**TOWN OF WELLINGTON
PLANNING COMMISSION**

Date: March 2, 2026
Submitted By: Brittany Lenoir, Planner III
Subject: Public Hearing for Minor Subdivision of Outlot A, Wellington Downs Subdivision, and concurrent Site Plan Review for a Residential Apartment Development proposed at 4101 Jefferson Avenue

CONSTRUCTION PLANS FOR WELLINGTON DOWNS OUTLOT A

SHEET:
4 OF 27

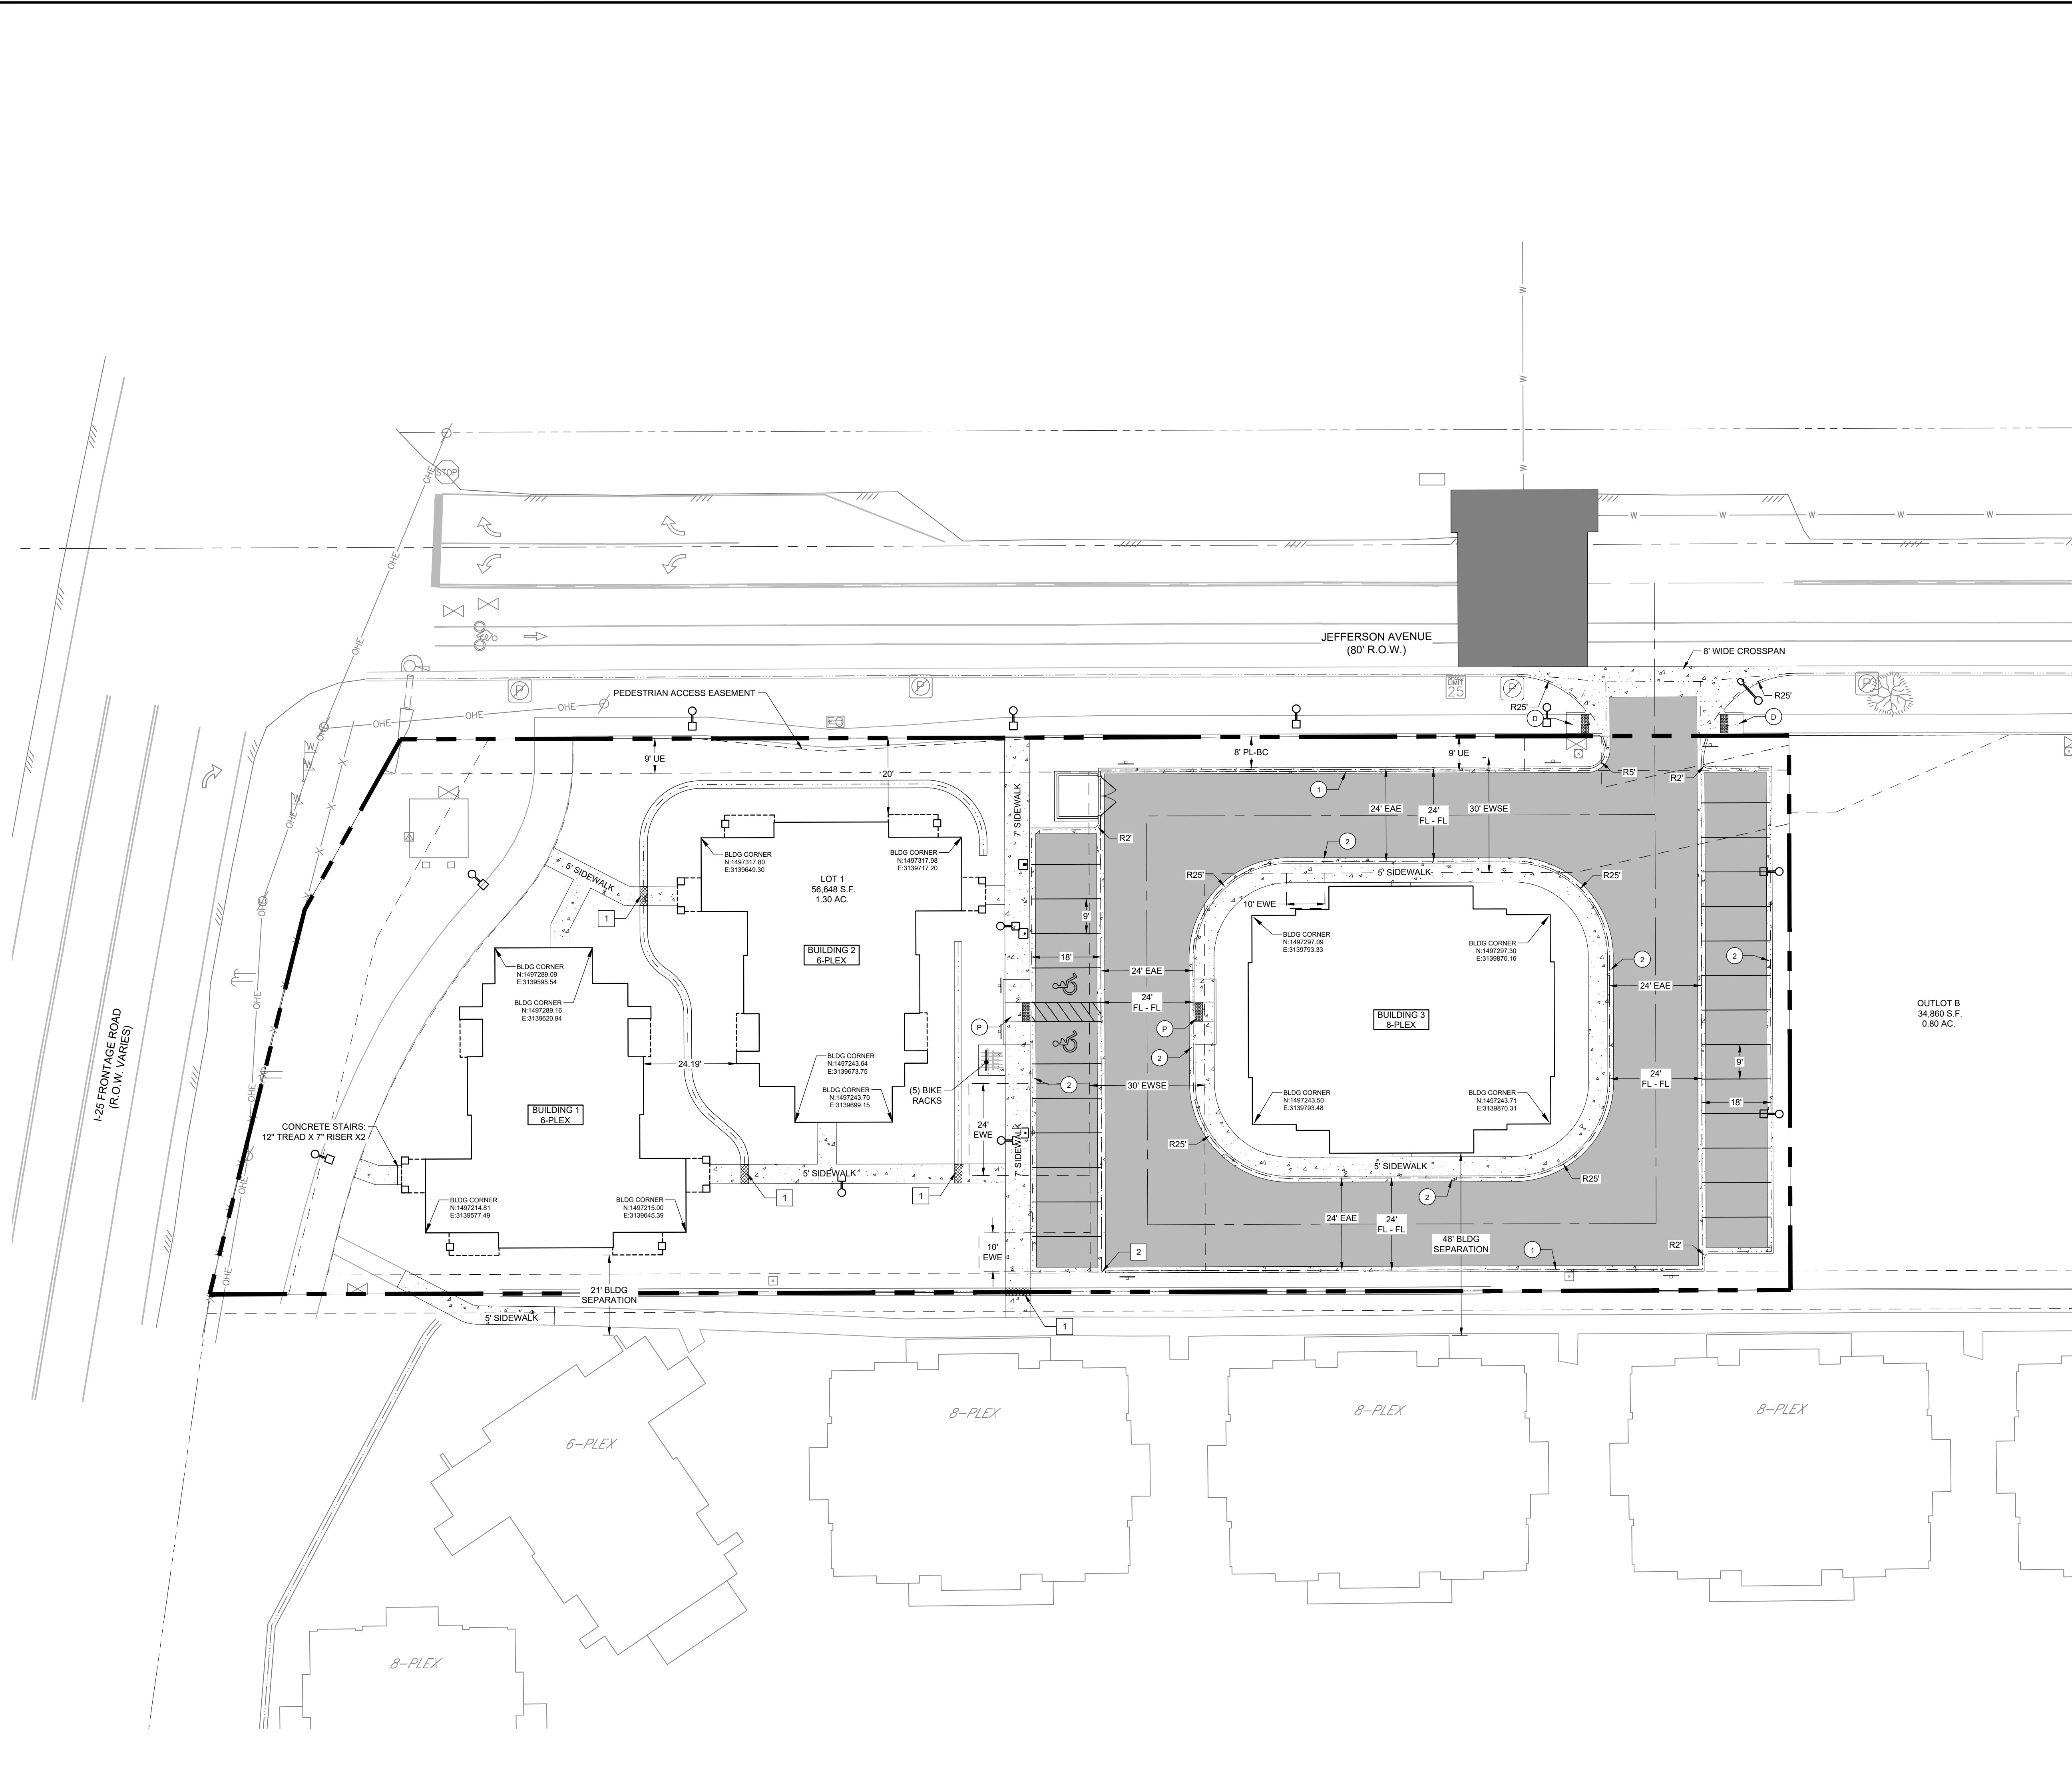
- A table of the required and provided parking spaces is included on page 4 of 25 of the project plans.
 - The minimum off-street parking requirements are being met with this proposal.

WELLINGTON DOWNS OUTLOT A IRRIGATION LEGEND & NOTES

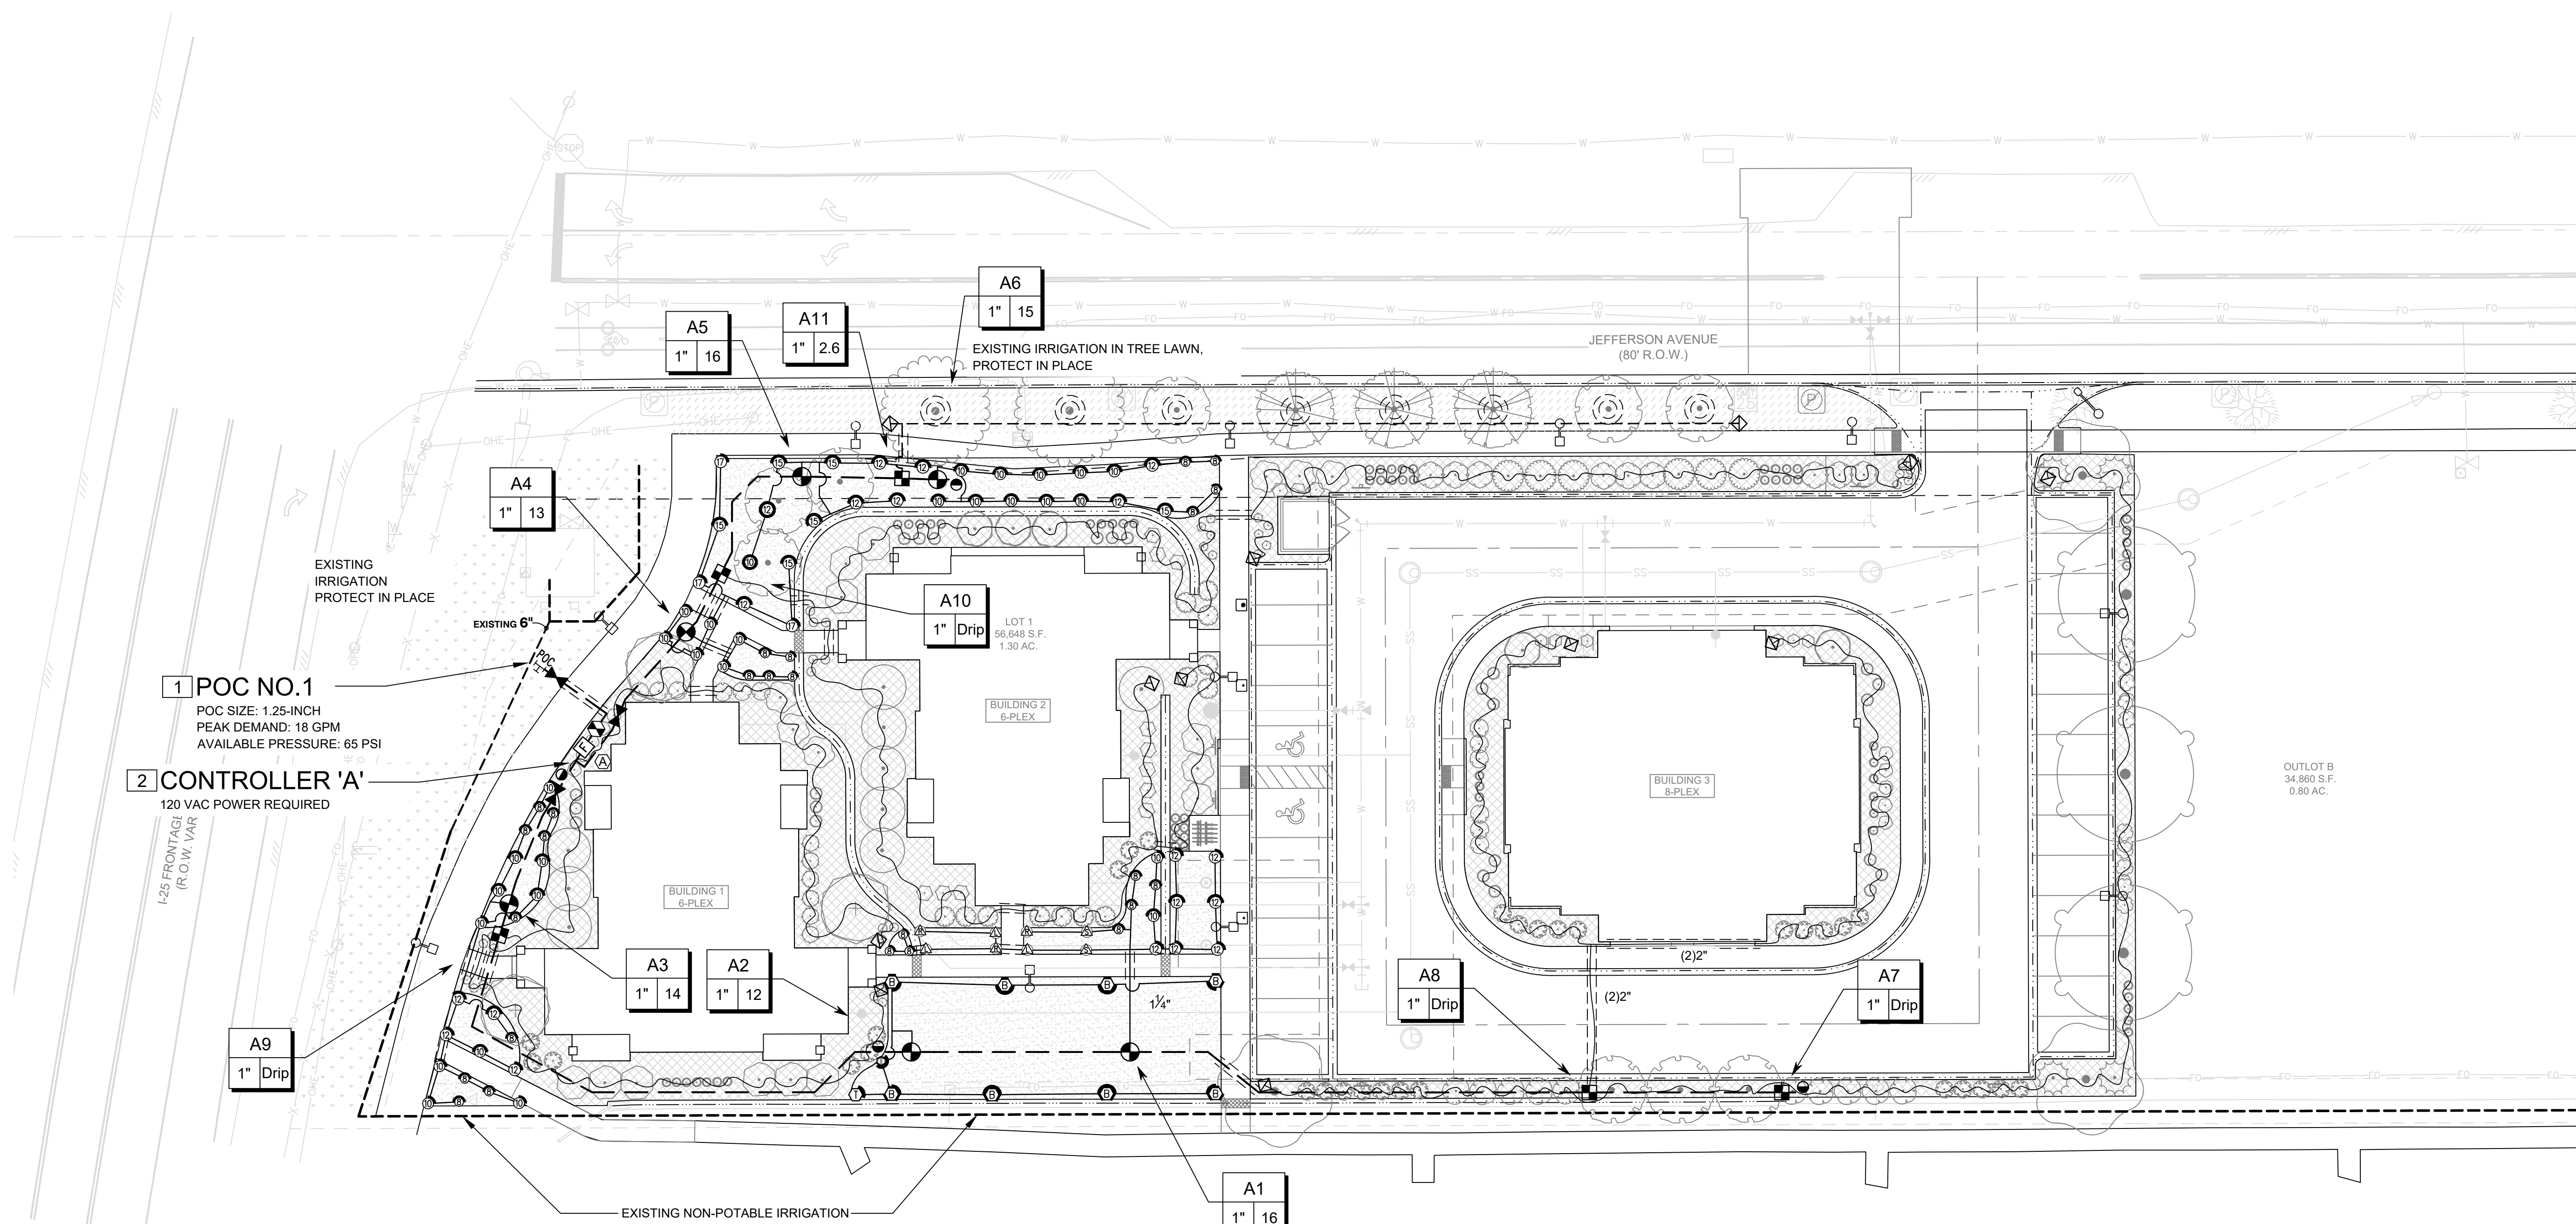
- Irrigation plans have been included in the plans (page 23 of 27, sheet IR1.1) and sufficient irrigation lines are proposed to meet the needs of the proposed landscaping.

SITE PHOTOMETRIC PLAN
SCALE: 1" = 20'

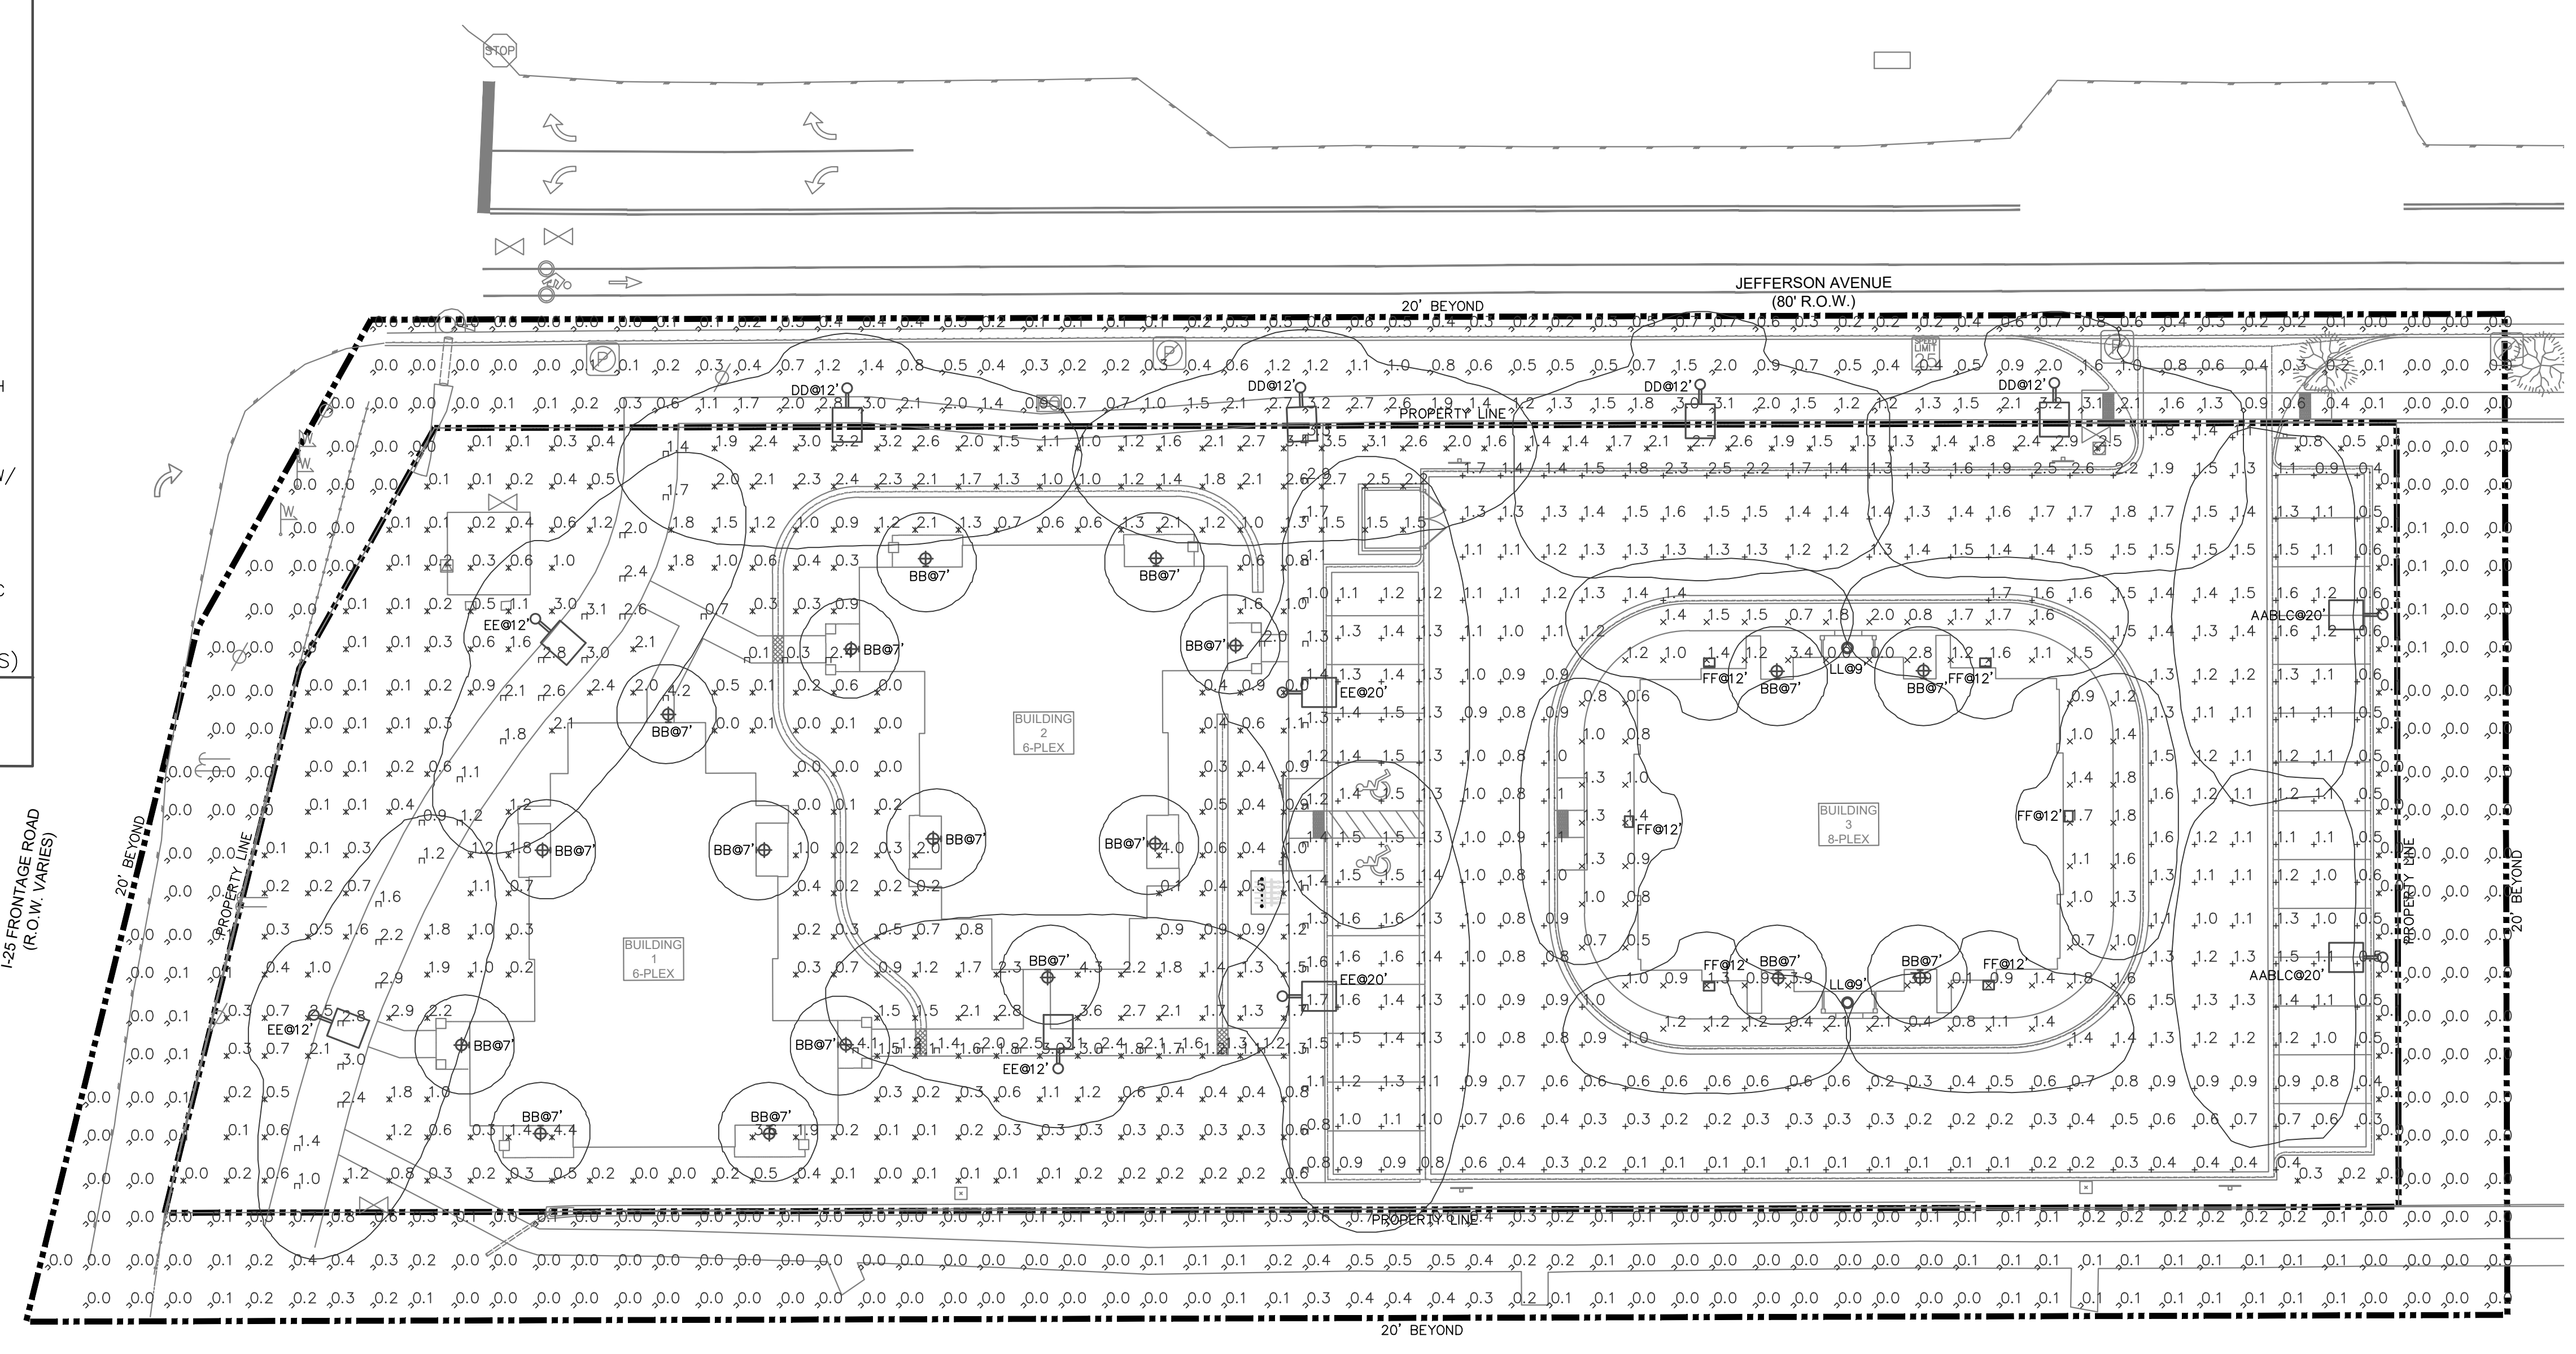
- Exterior Lighting:
 - A photometric plan was provided with the plan set for the site plan on page 26 of 27 (Sheet SP-1).
 - The Town's minimum illumination level for all parking areas and pedestrian paths is 1.0 footcandle. Most parking and circulation areas satisfy the minimal 1.0 footcandle illumination criteria.

- There is a discrepancy in the plans where a streetlight is shown at the driveway entrance from Jefferson Avenue that is not reflected in the photometric plans. A condition of approval has been included to reconcile the discrepancy and provide sufficient illumination at the driveway entrance.

- Revisions to the lighting and photometric plans to include street lights as required by the Town Engineer and to reconcile the streetlight details for the driveway entrance on Jefferson Avenue.
- Revisions to the EV charging pedestal location to ensure adequate widths for all walkways, as needed.
- Stamped engineering design plans and a modification application submitted to the Town Engineer for review and acceptance, and accepted designs reflected on the revised site plans.
- WFPD letterhead signed by the Fire Chief accepting the fire line design plans.
